**Subject:** BOS File No. 200800, 3516 and 3526 Folsom Street, Inconsistent Usage of 'Project Site' definition

Re: Appeal of Revised Final Mitigated Negative Declaration (RFMND) for 3516 and 3526 Folsom Street, BOS File No. 200800

Re: Appeal of CEQA Revised Final Mitigated Negative Declaration  
BOS File No. 200800 - Planning Dept. Case No. 2013.1383ENV  
3516 and 3526 Folsom Street

**Subject: San Francisco City and County (CCSF) Planning Case No. 2013.1383ENV Building Permit Application Nos. 2013.12.16.4318 and 2013.12.16.4322 3516 and 3526 Folsom Street- Appeal of CEQA Revised Final Mitigated Negative Declaration**

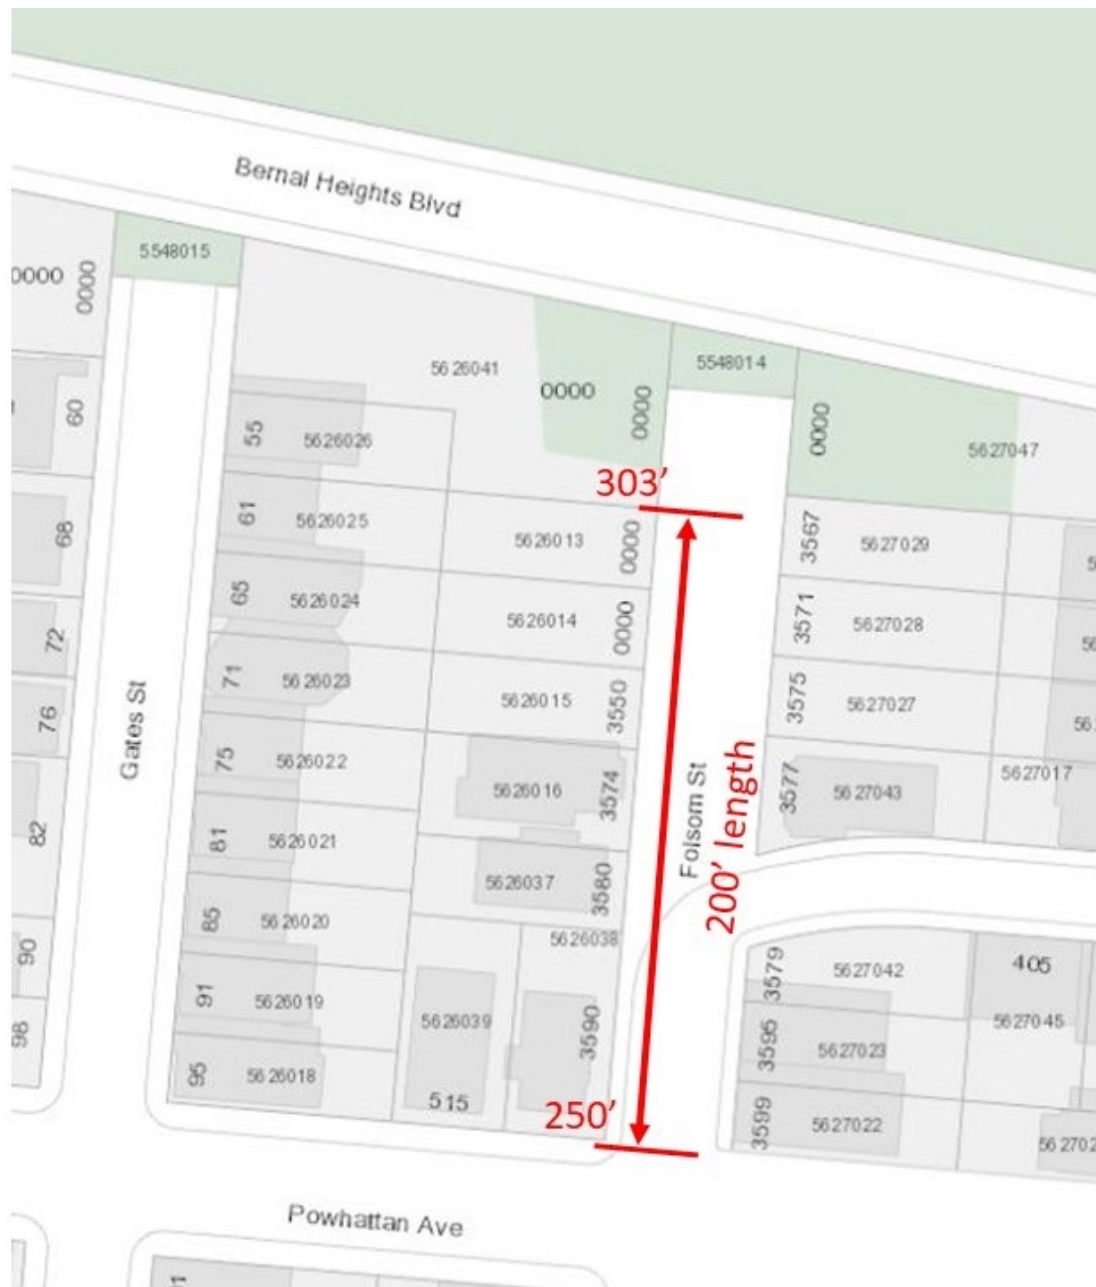
*Figure 1*, below, shows how the approximately 33 percent slope of the project site was determined. The project site, which includes the two lots at 3516 and 3526 Folsom Street, has an elevation of approximately 303 feet at the northeastern corner. The elevation at the southeastern corner is approximately 286.5 feet. The width of the project site is 50 feet. Slope is calculated as the ratio of vertical change over horizontal change. As such, 303 feet minus 286.5 feet is 16.5 feet difference in elevation (vertical change), which, when divided by the 50-foot width of the project site (horizontal change) is 0.33, or 33 percent.

Figure 2: Slope of Folsom Street North of Powhattan Avenue with Project Implementation

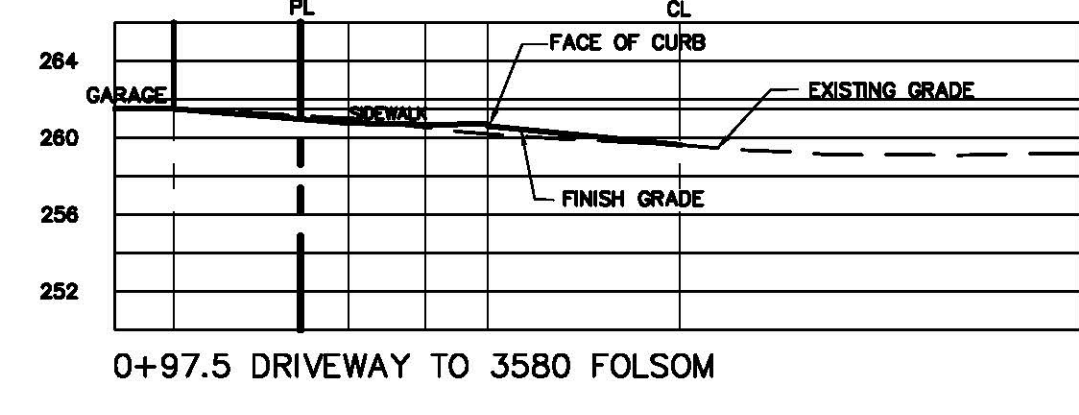
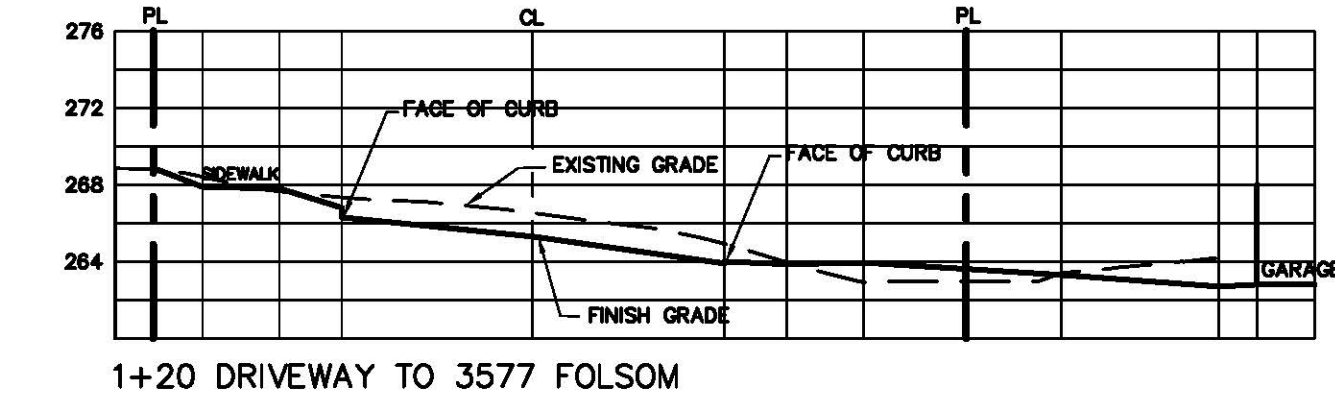
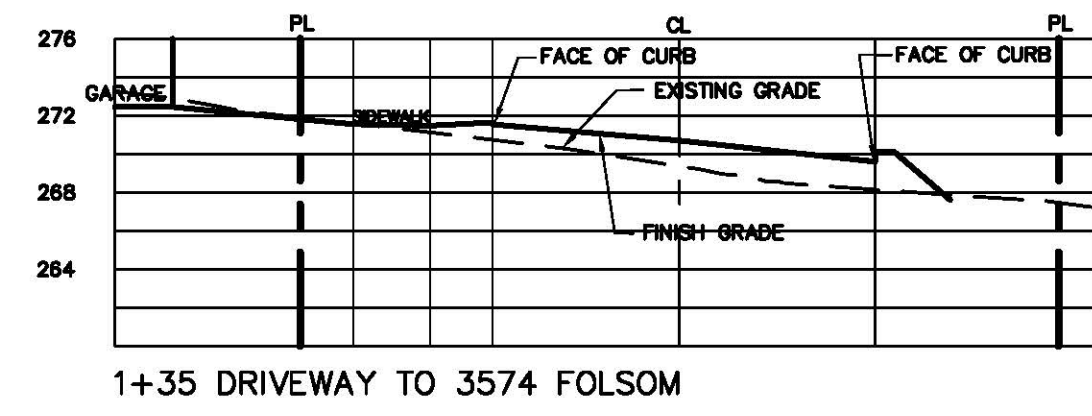
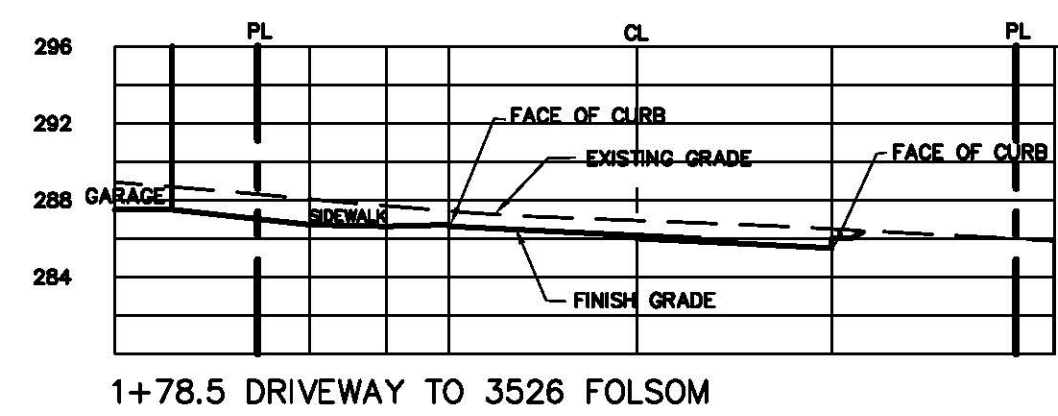
Figure 2, below, shows the slope of Folsom Street north of Powhattan Avenue with the extension of Folsom Street, which would be approximately 27 percent.

PROFIE  
& CROSS  
SECTIONS  
PLAN

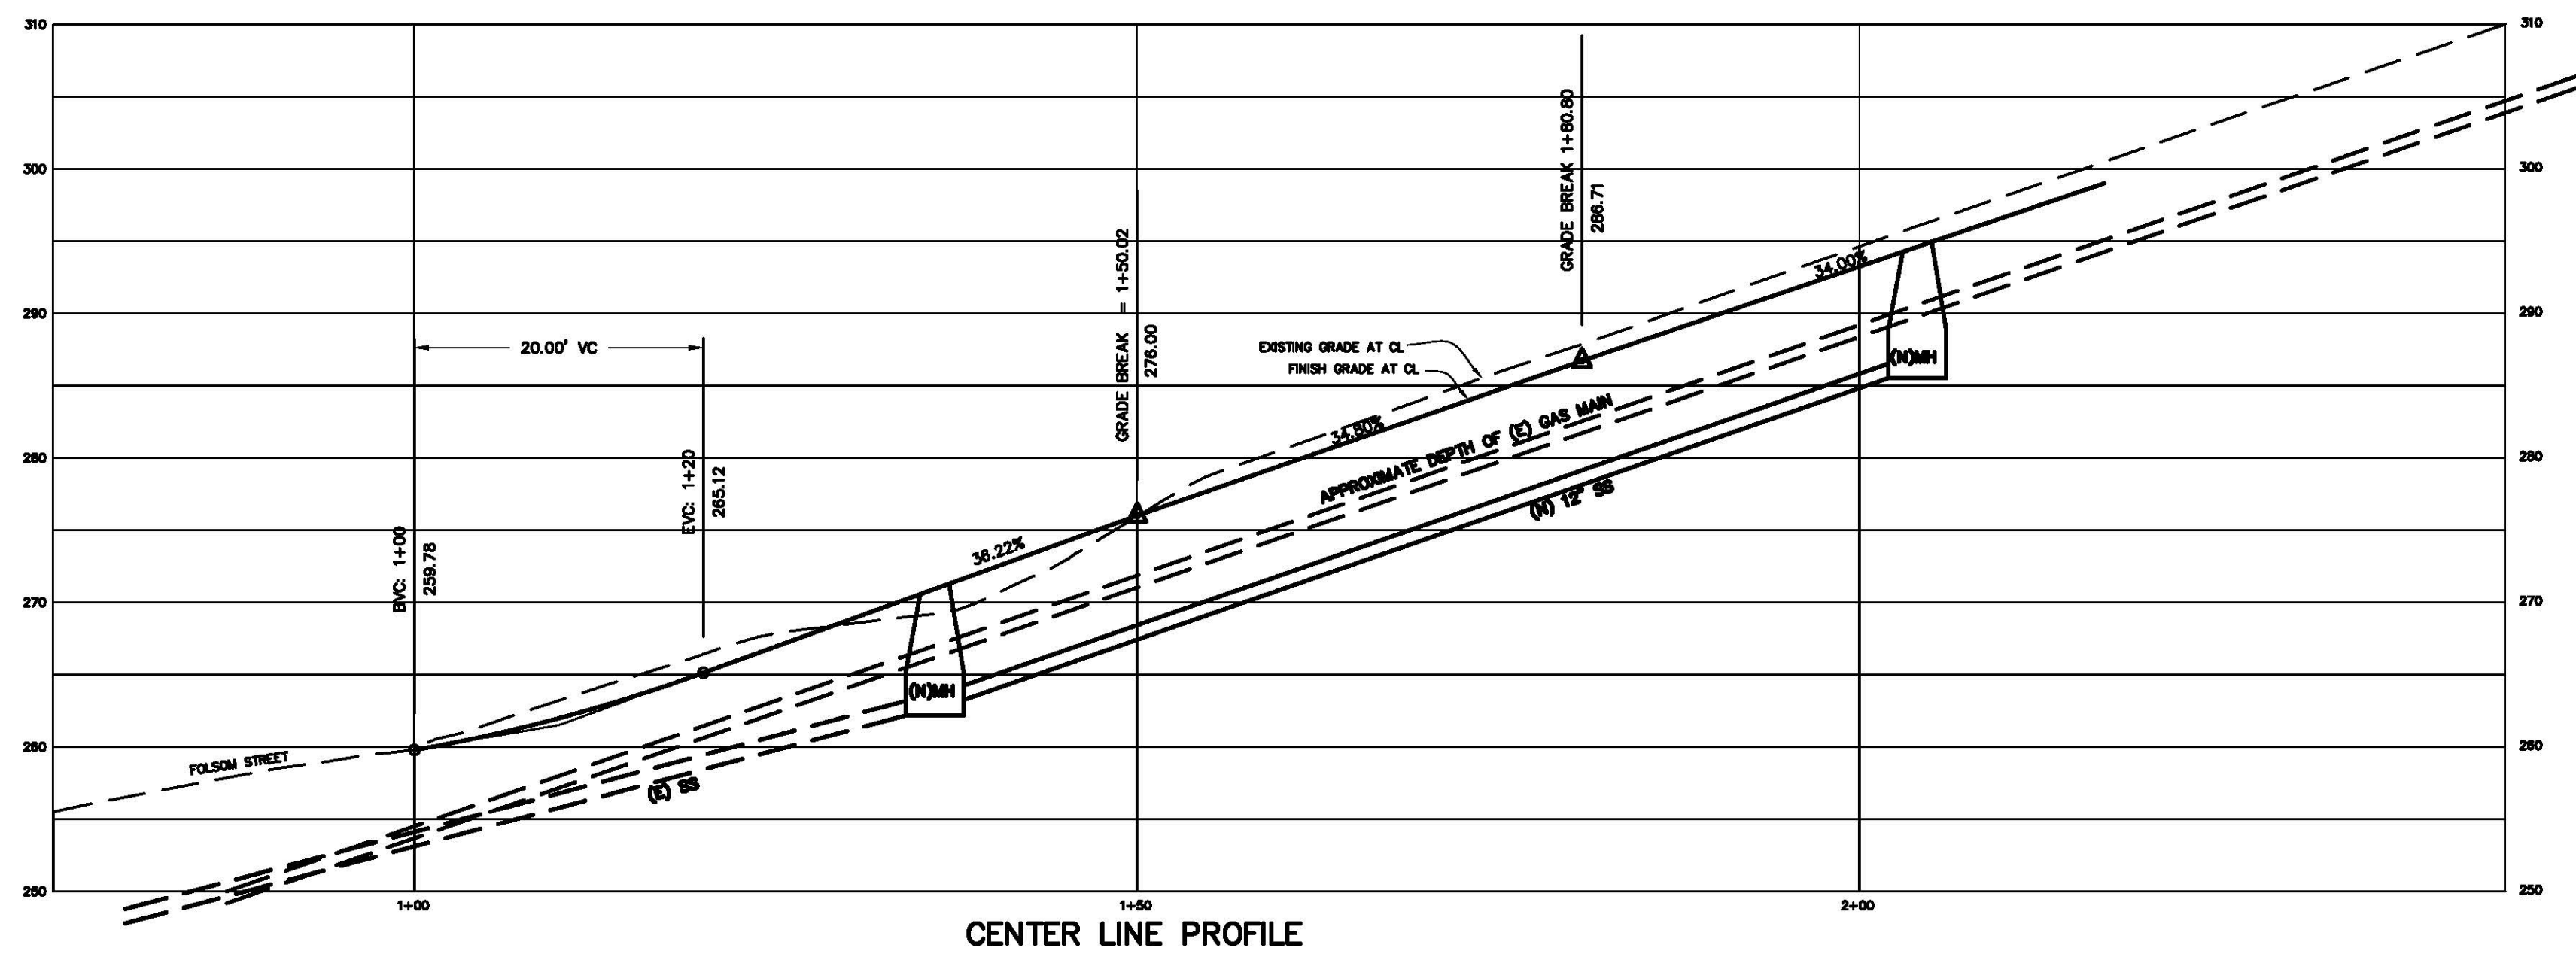
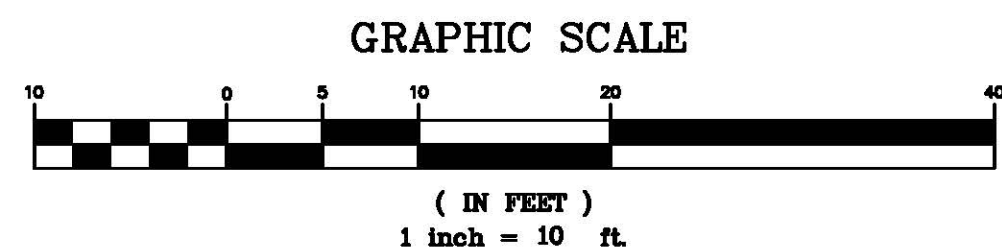
Finally, drawings prepared by the project sponsor's civil engineer, David Franco, shows the finished street grade with three different slope values depending on the segment of the extension: 34%, 34.8% or 36.22%. [See attached document, SLOPE 34-36.22 pct.]

C1.0

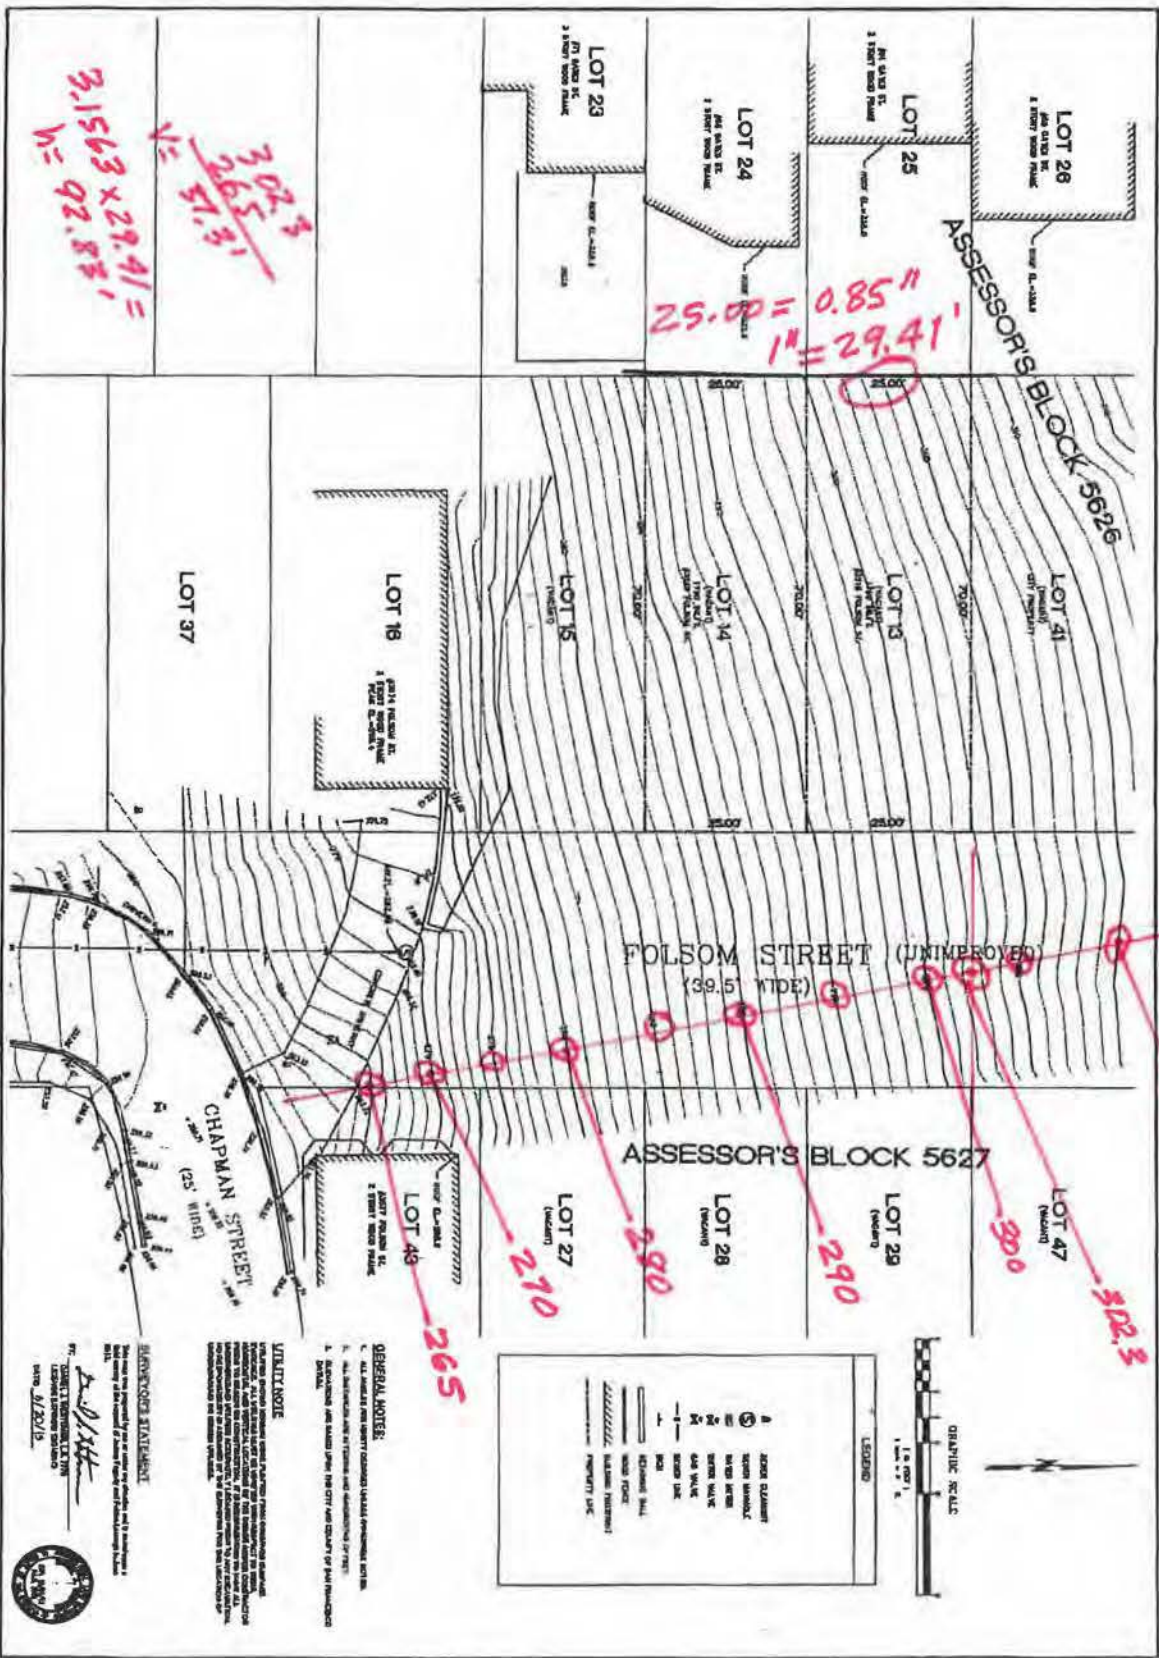
By contrast, the appellant's geotechnical engineer, Lawrence Karp, calculated a slope value of 40.3% for the ungraded slope within the Folsom Street right-of-way. This slope value is based on a horizontal change of 92.83 feet beginning at an elevation of 302.3 feet, which is the same approximate elevation used by the Planning Department, and extending downhill within the boundaries of the project site, only if the project site is defined to include the Folsom Street right-of-way. [See attached document, SLOPE 40.3 pct.]

$$\frac{37.3}{92.83} = 40.3\%$$

$$\tan^{-1} 0.4026 = 22.0^\circ$$
